Appendix 2 – Response to ‘Fact checking’ exercise

Table A – Fact-checking exercise for Consultation Draft (Regulation 18)

Figure 4: Walking Isochrone from Albourne Primary School to Site (courtesy of TravelTime Mapping)

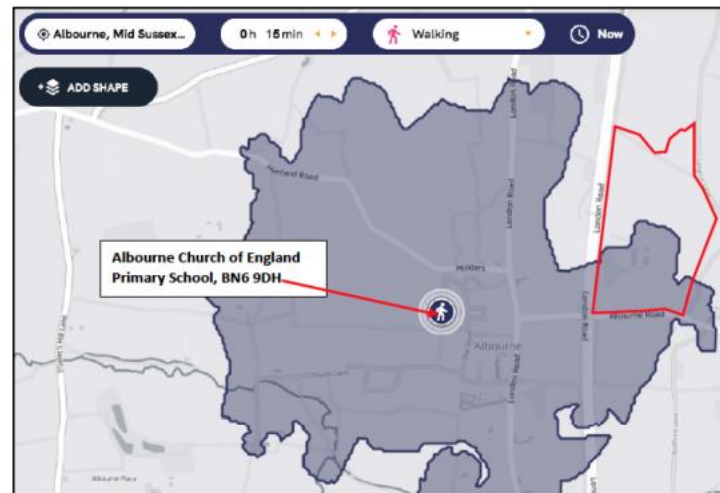
12 – primary school -the draft proforma (for fact checking) sets out that the site is within a 20-minute walk of a Primary School. However, our own review of Time Travel Mapping however shows that a large proportion of the site could walk to Albourne Church of England Primary School with a 15-minute walk – as demonstrated in Figure 4 below.

Again, we have cross referenced this with evidence held within google maps and using the main farm buildings in the middle of the site as the measurement point. This confirms that the lion's share of the site is indeed located within a 15-minute walk of Albourne Primary as demonstrated in Figure 5 below.

Figure 6: Walking Isochrone from Hurtpierpoint Primary School to Site (courtesy of TravelTime Mapping)

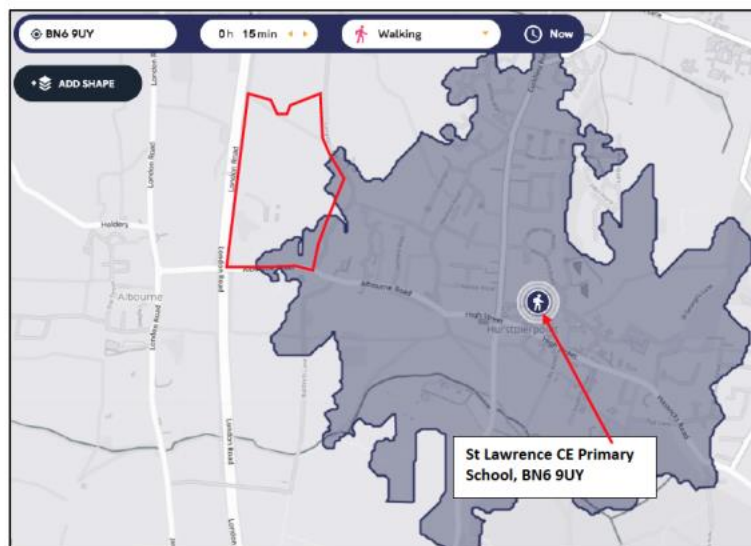
It should also be noted that the site is also located within walking distance of another school, St Lawrence CE Primary School in Hurstpierpoint. This is slightly further away but still eastern parts of the site are also within a 15-minute walking distance as demonstrated in Figure 6 below.

Combined, the lion's share of the site is within a 15-minute walk of a primary school and as such we ask for the assessment to be revised from 'Neutral' to 'Positive'
